**Replace Wastewater Plant South Rim Village
GRCA-257282**

**100% Complete Construction Documents
Addendum 4**

September 8, 2026

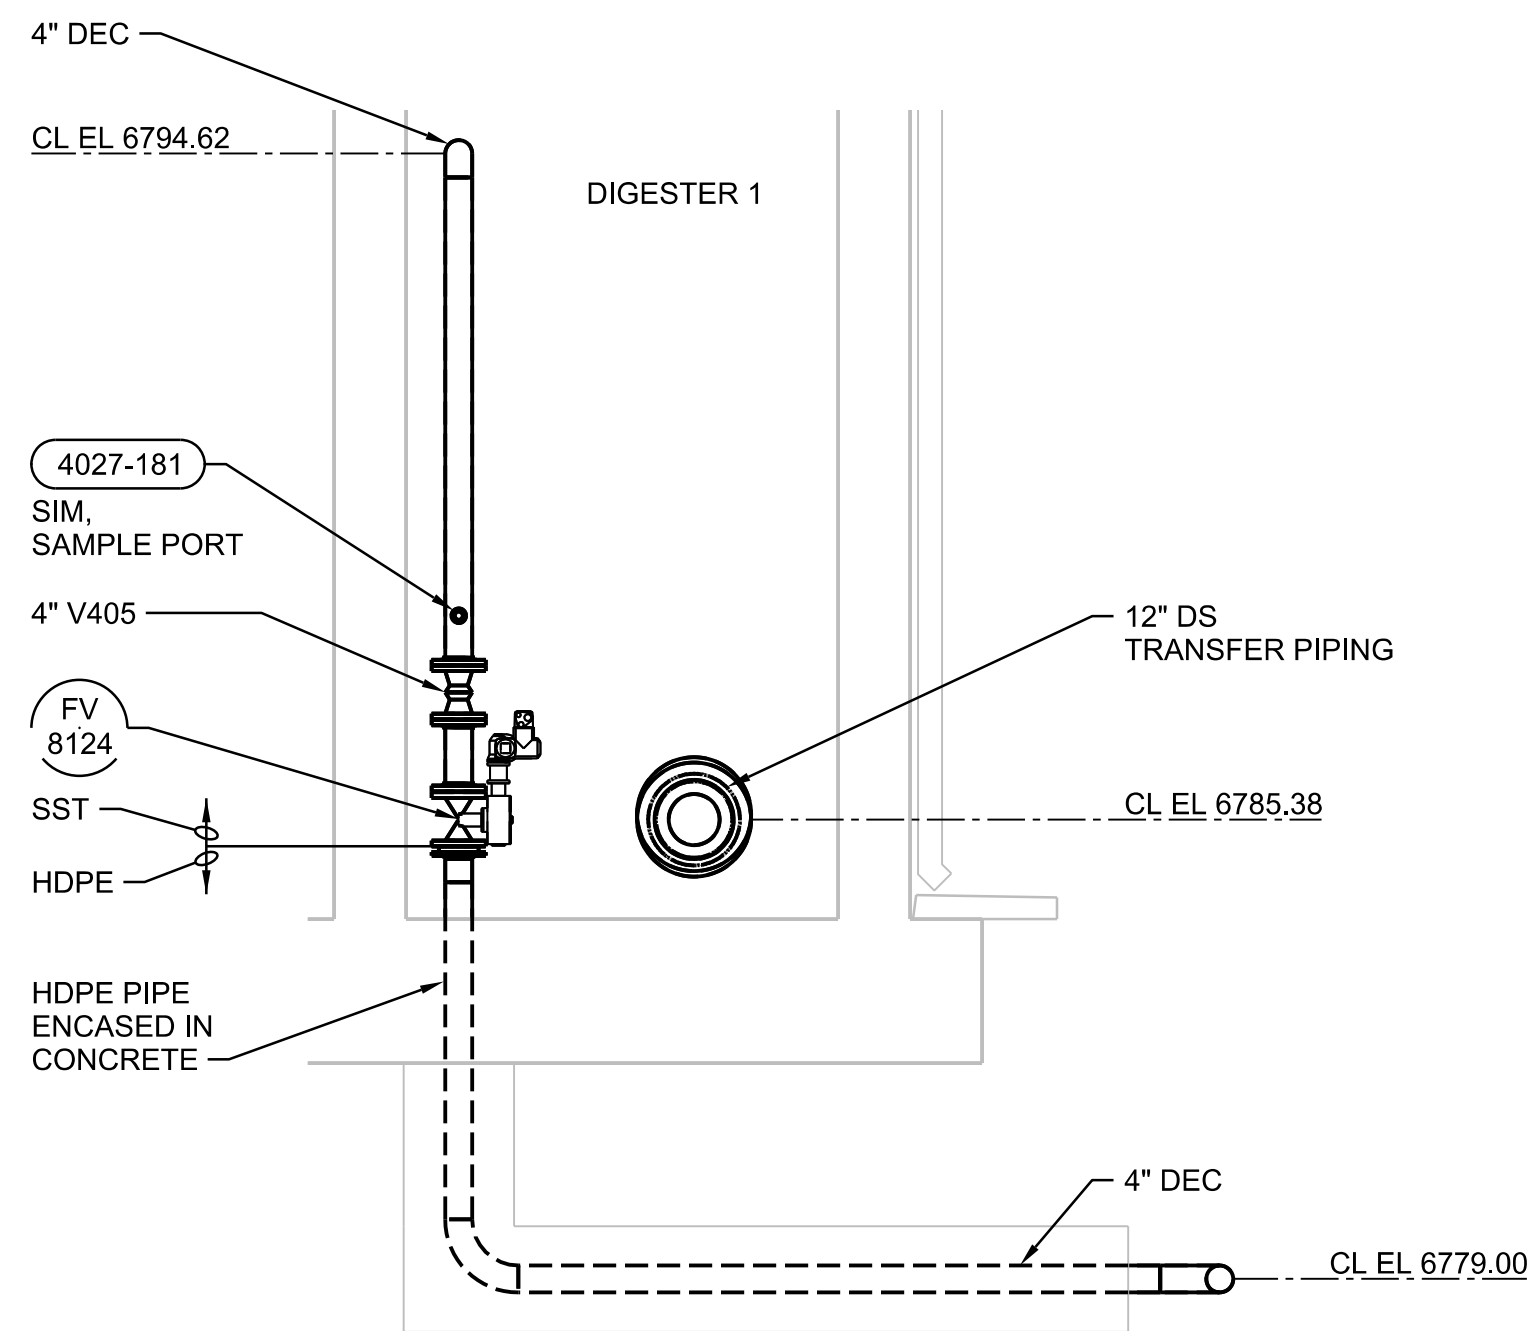
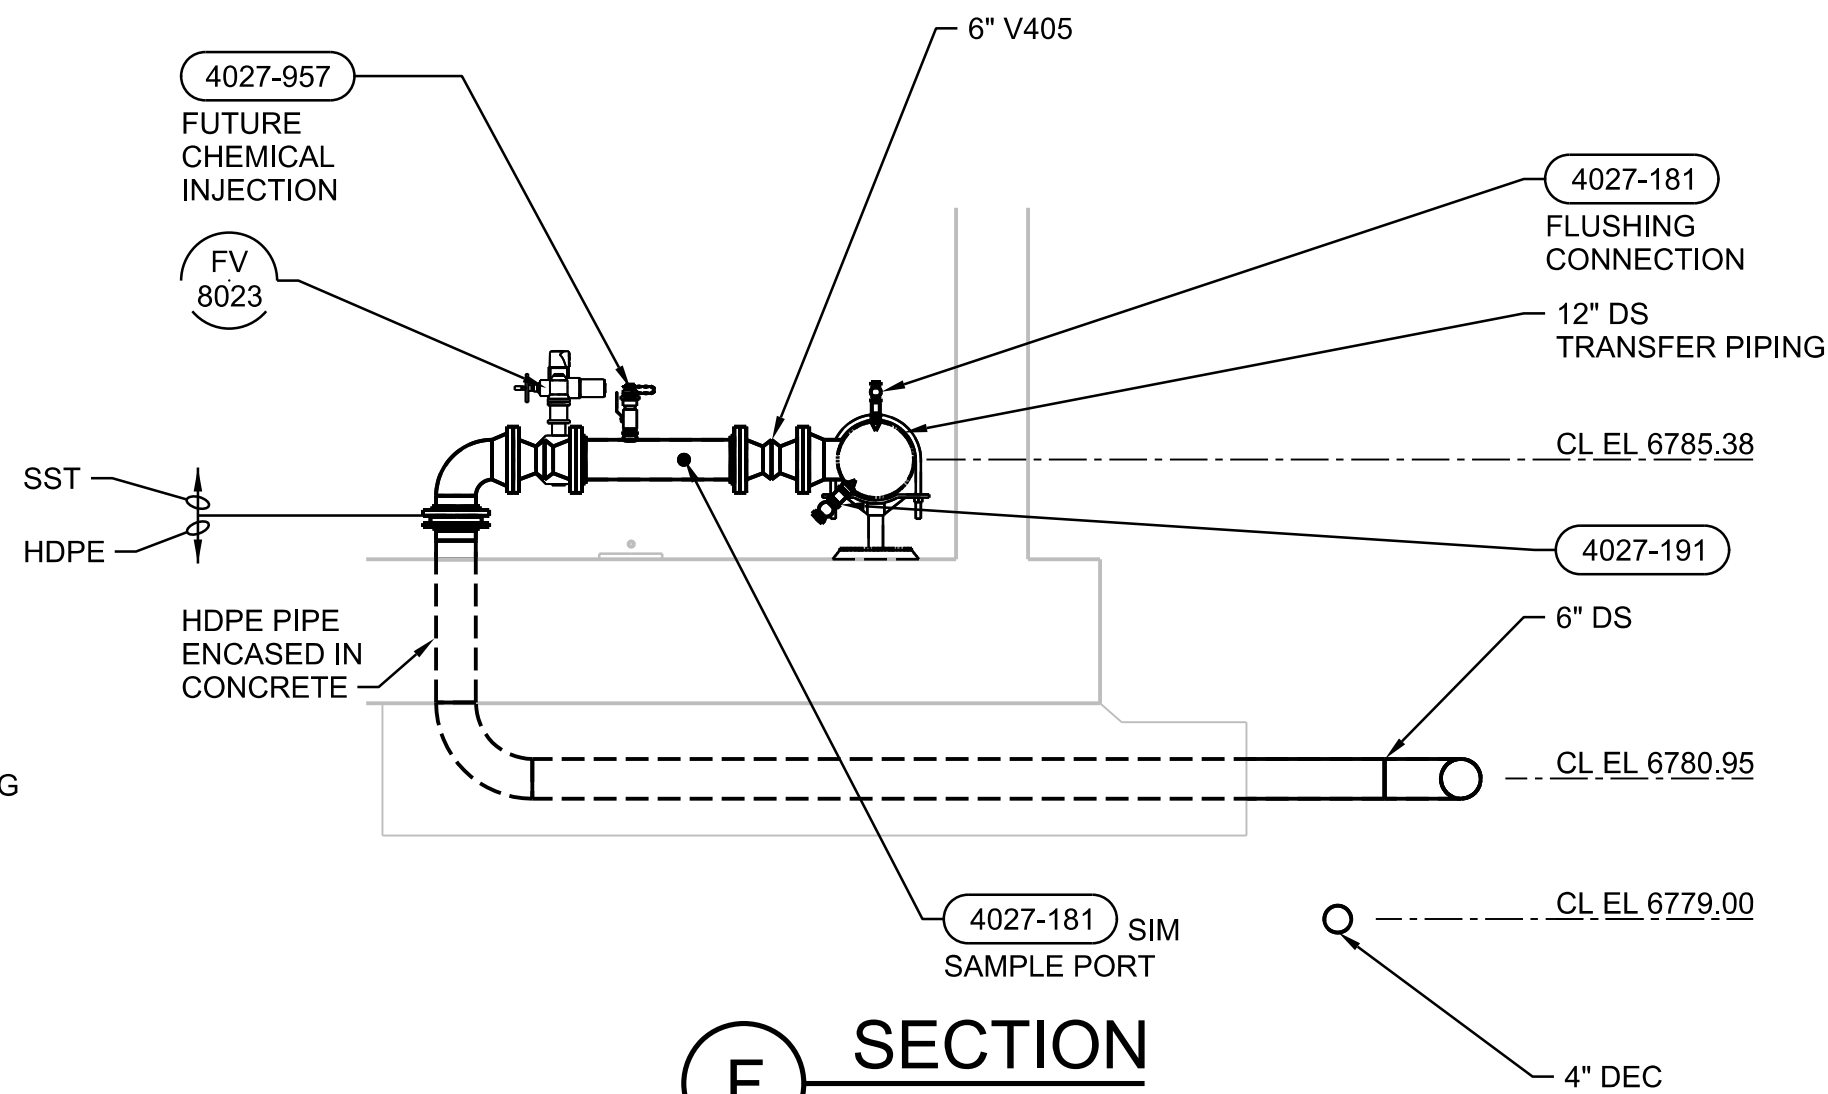
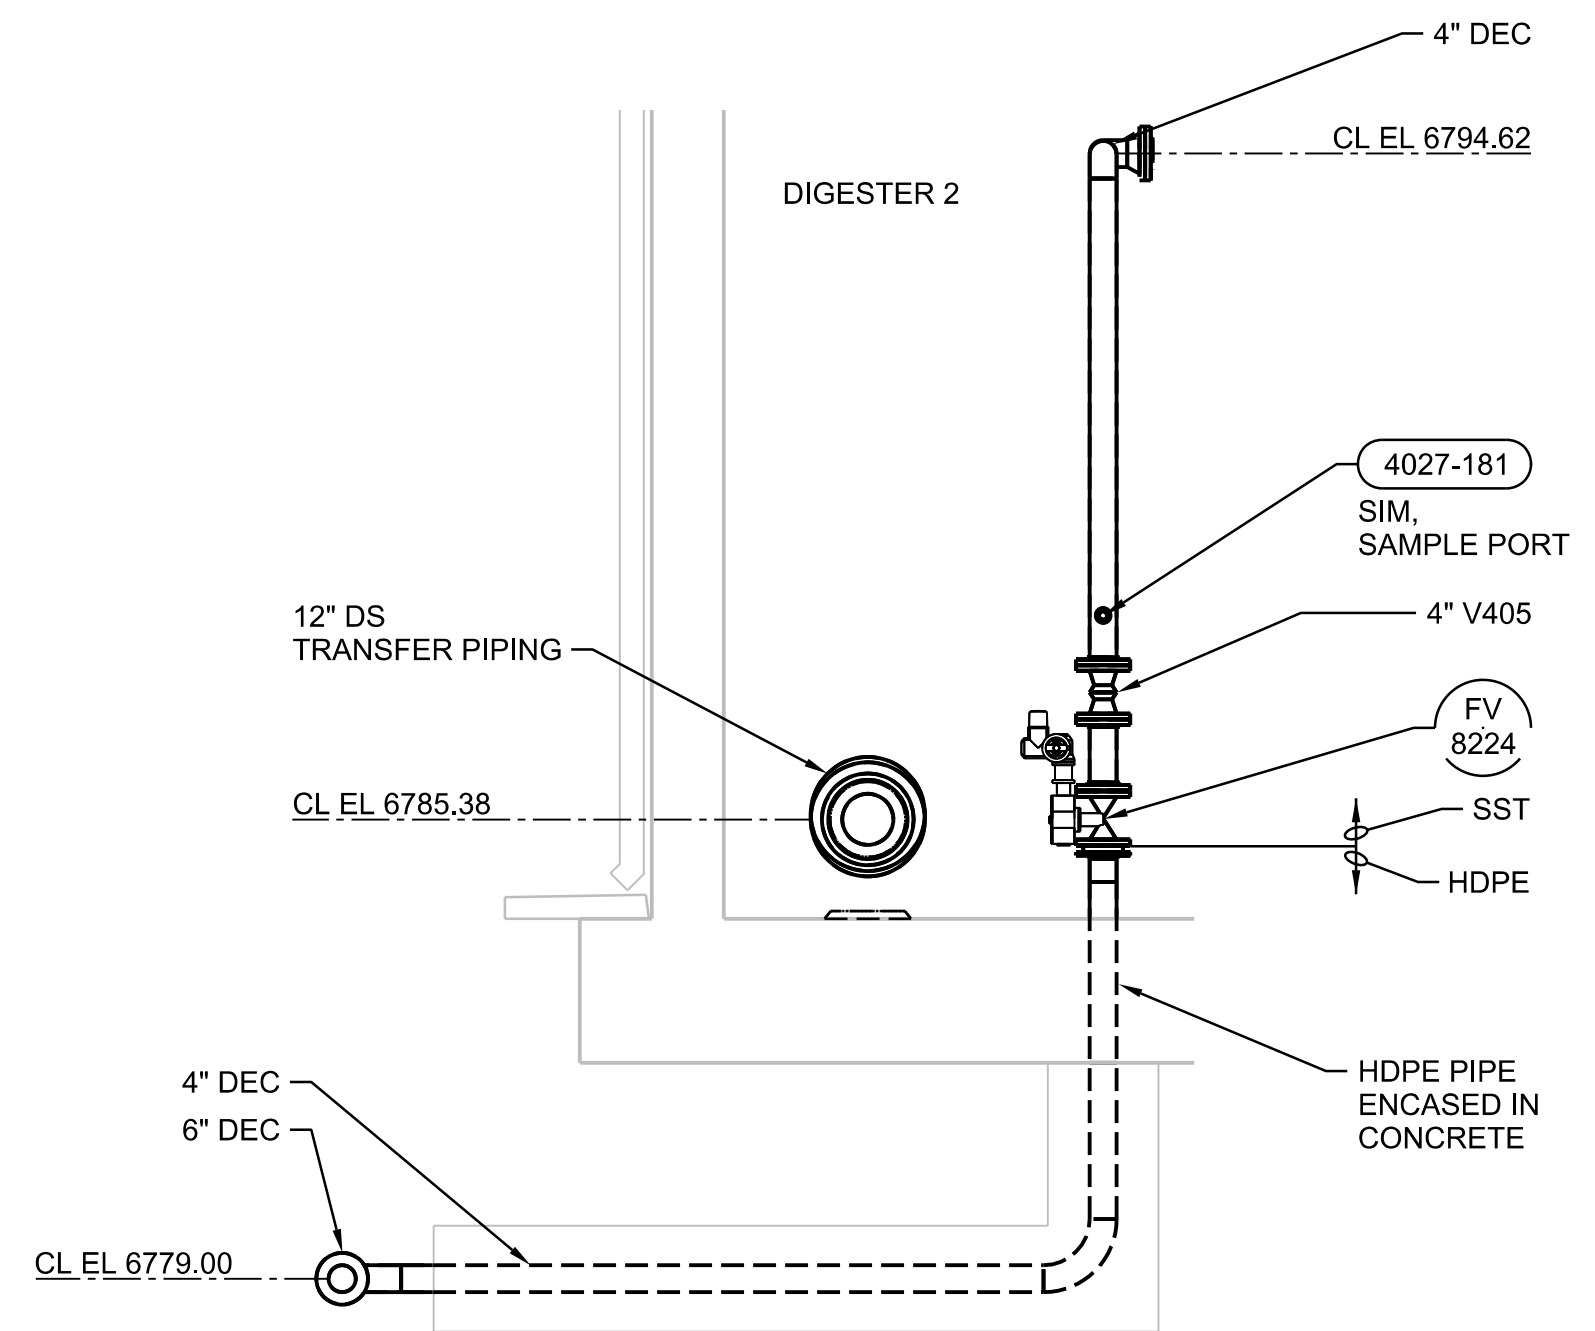
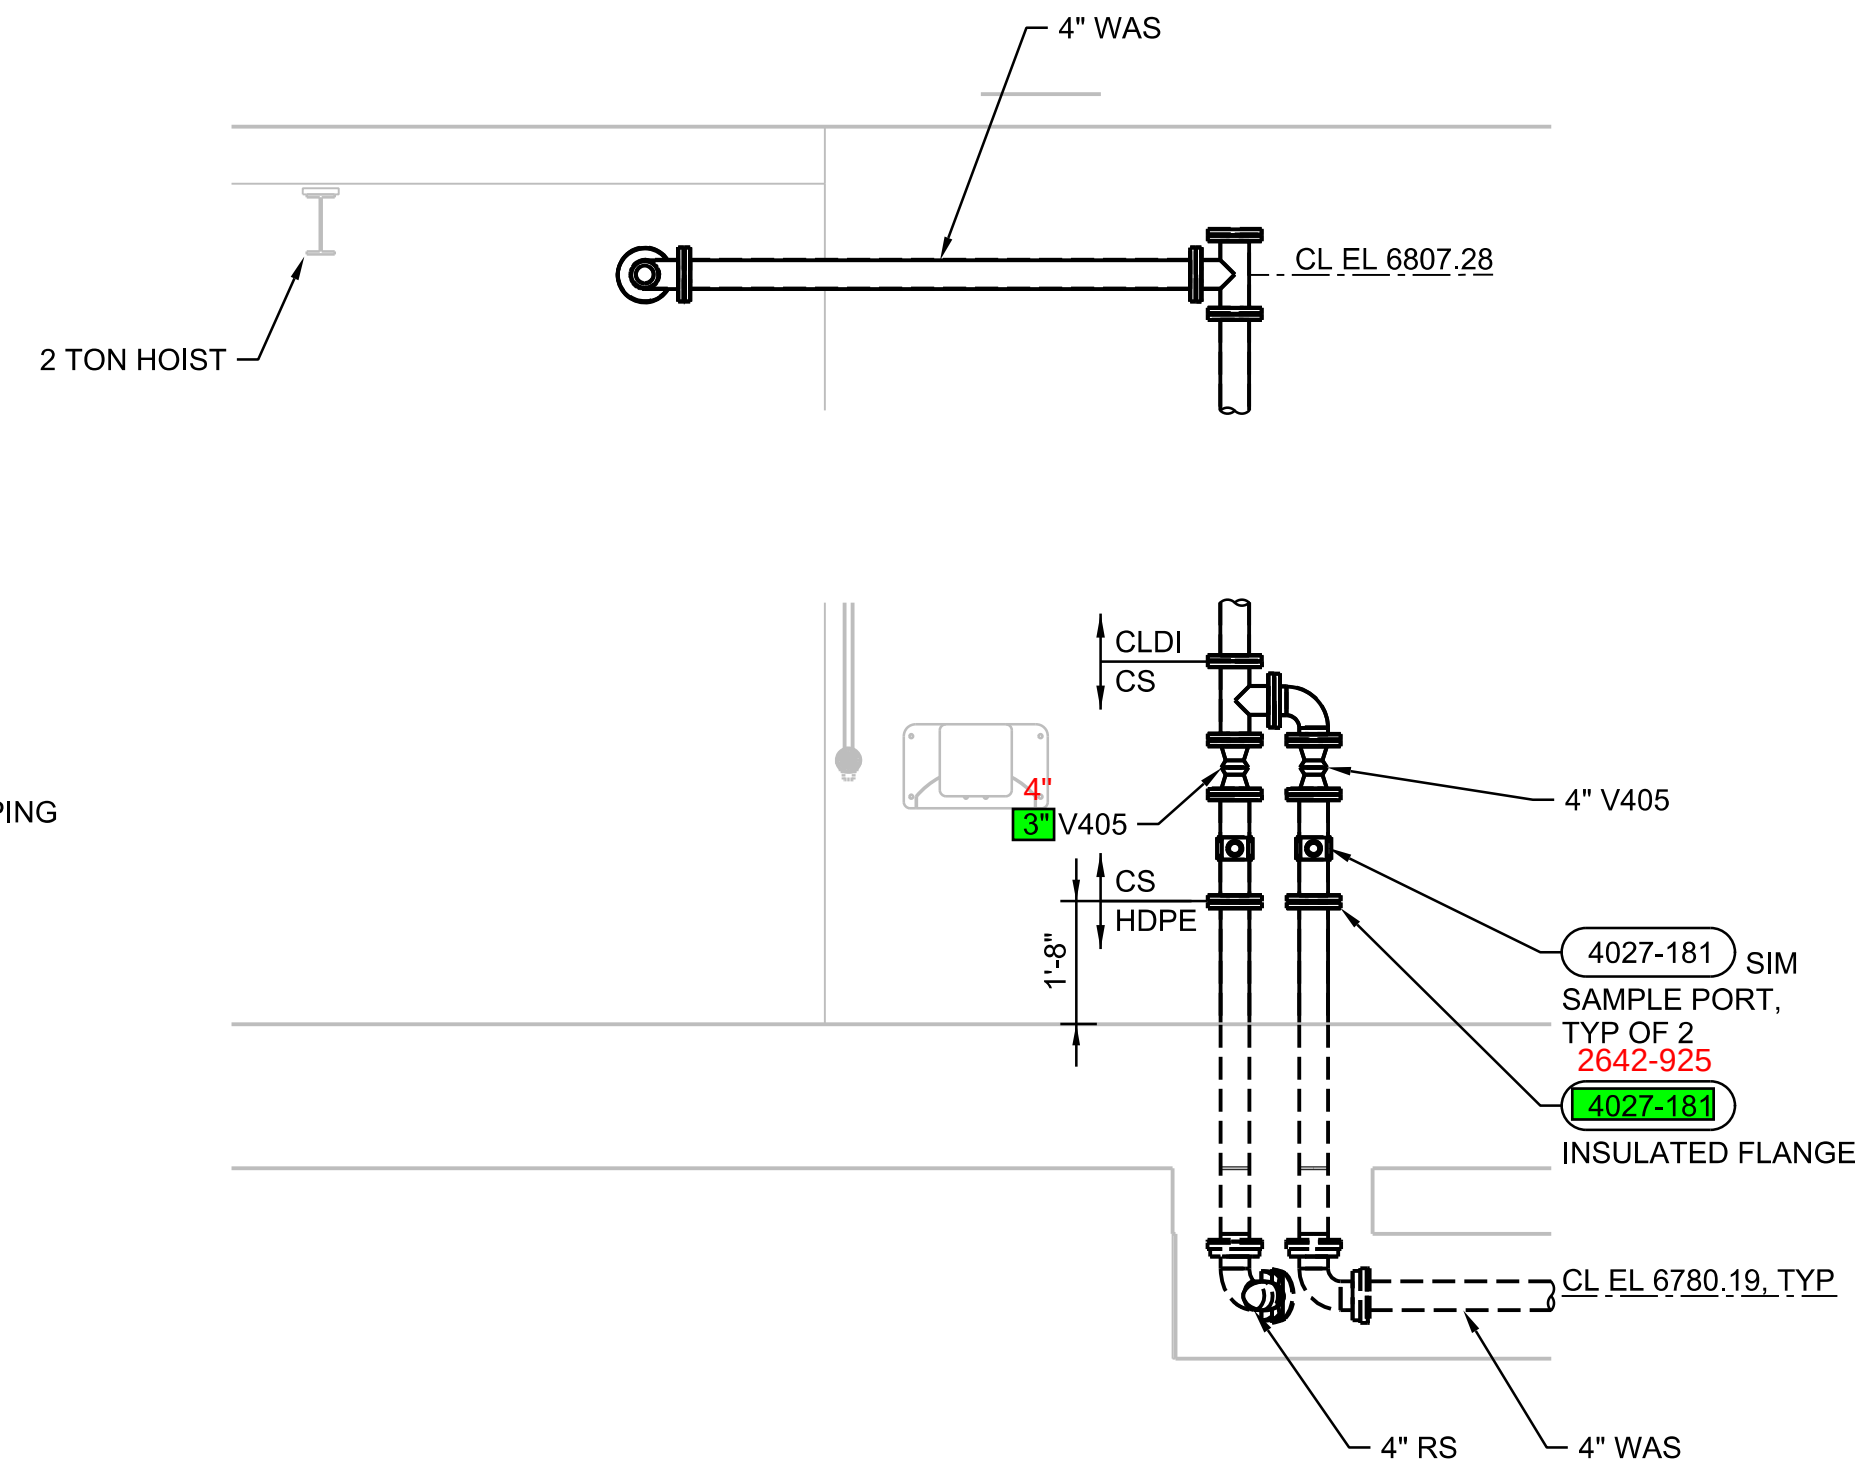
New or Updated	Sheet No.	DWG No.	Sheet Name	Description
Updated	391	87S1030	Compost Facility Structural Foundation Plan and Detail	Added Detail 2 for drilled pier reinforcement
Updated	361	80D3002	Digester Facility Mechanical Sections	Revised detail number and valve size
